Addendum 7

Sugarcreek Water Treatment Plant and Wellfield Improvements

Addendum No. 7
June 6, 2022

CITY OF CANTON, OHIO
WATER DEPARTMENT
SUGAR CREEK
WATER TREATMENT PLANT
PROCESS STANDARD DETAILS
SD-12

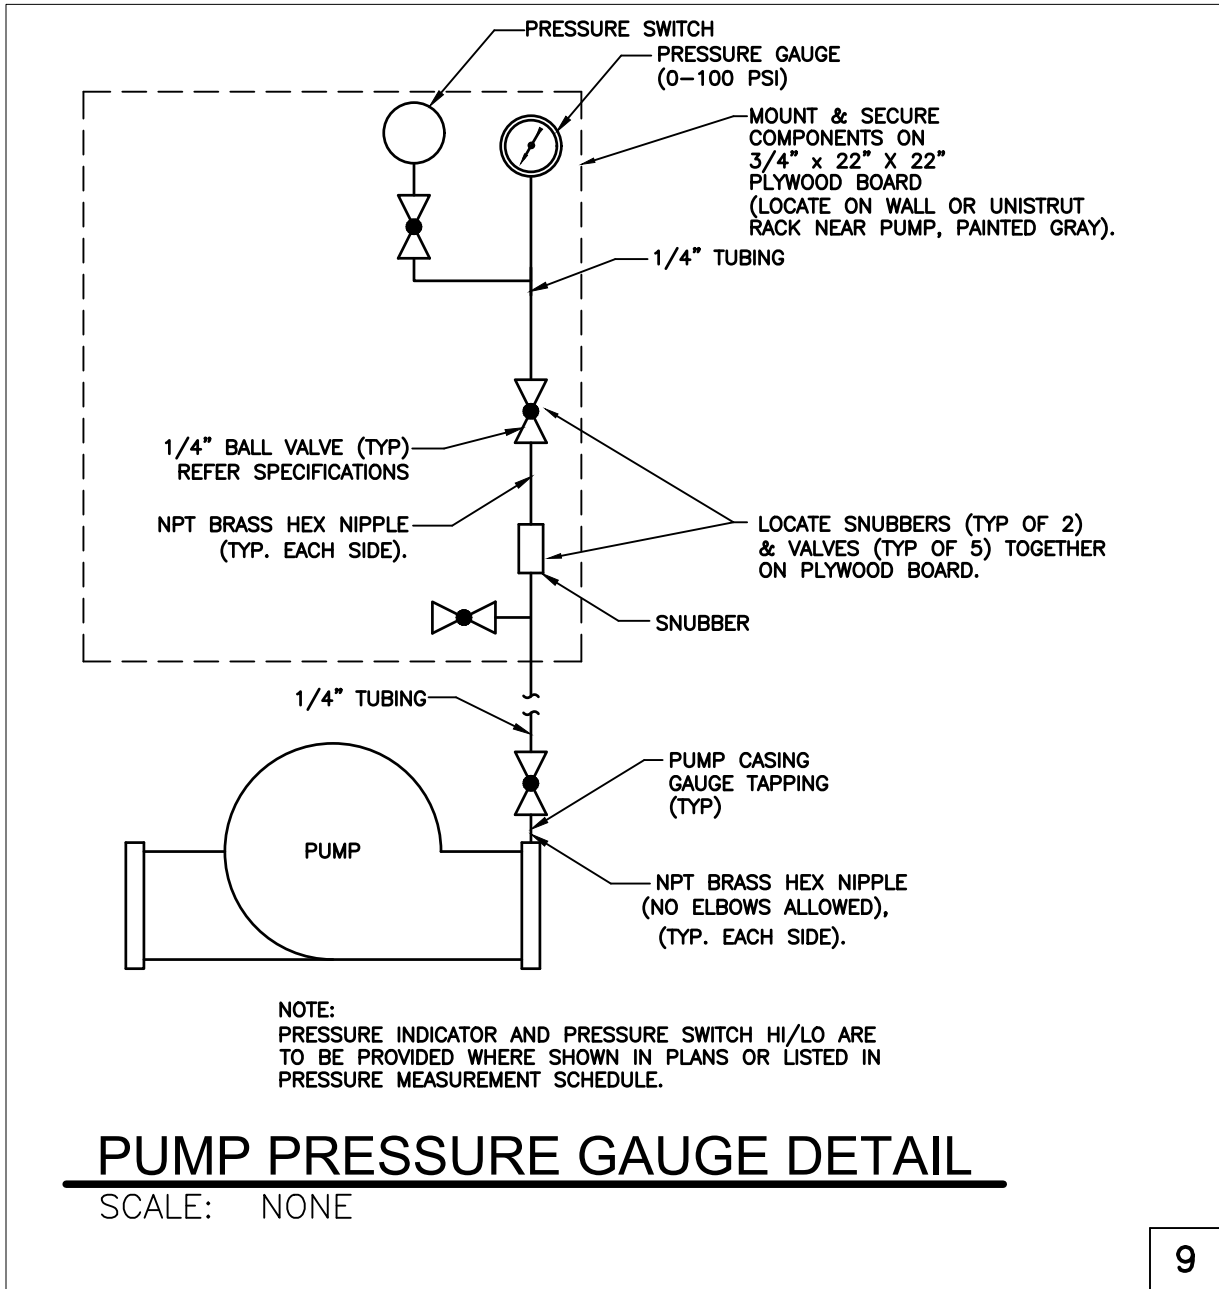
11. **Sheet SD-12, Process Standard Details Plate and Guides.** For Pump Pressure Gauge Detail, REPLACE with attached Sketch SD-12. Added pressure switch/ pressure indicator manifold piping.

GENERATOR P&ID

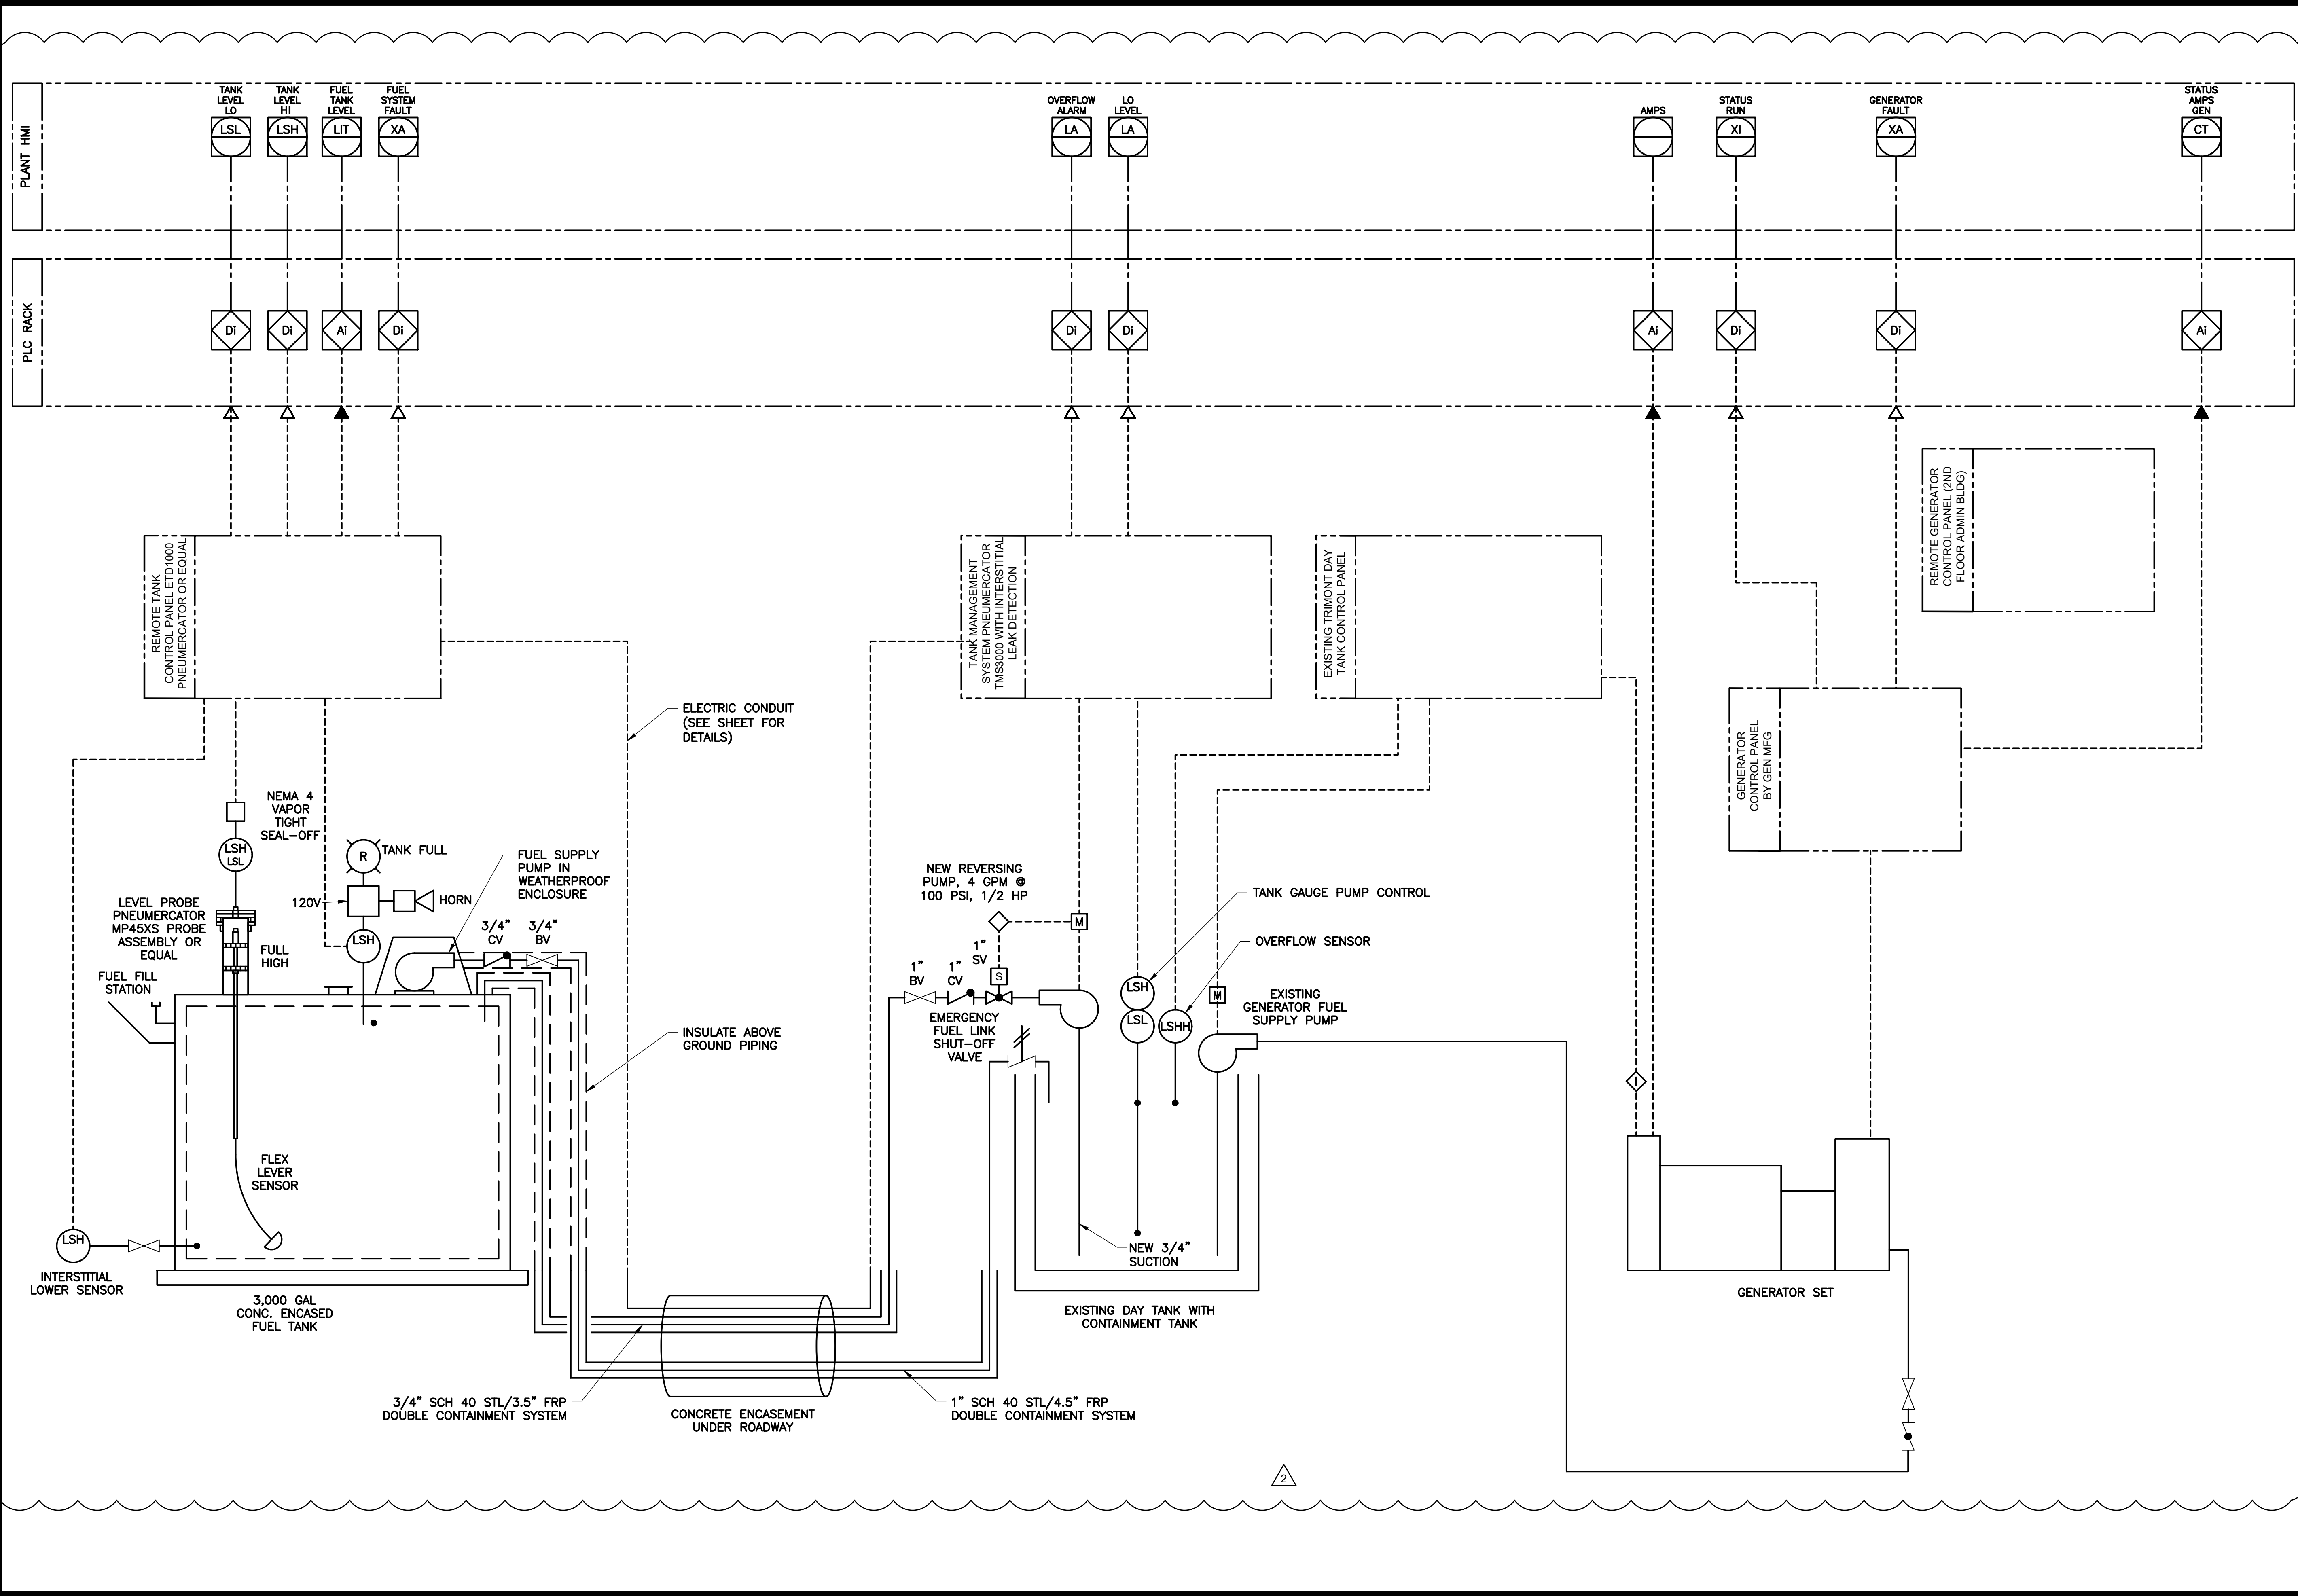
17. **Sheet E-57 – Filter Gallery Electrical Renovation Power Plan El. 975.** DELETE chlorine residual analyzers AIT 421 and AIT 426.
18. **Sheet I-33 – Generator P&ID.** REPLACE with attached I-33. Drawing was revised to show work at new 3,000 gallon aboveground storage tank and the existing day tank in the generator building including vendor supplied control panel, pump, instruments and controls. Electrical Contractor shall provide conduit and wiring to vendor supplied equipment, instruments, and controls.
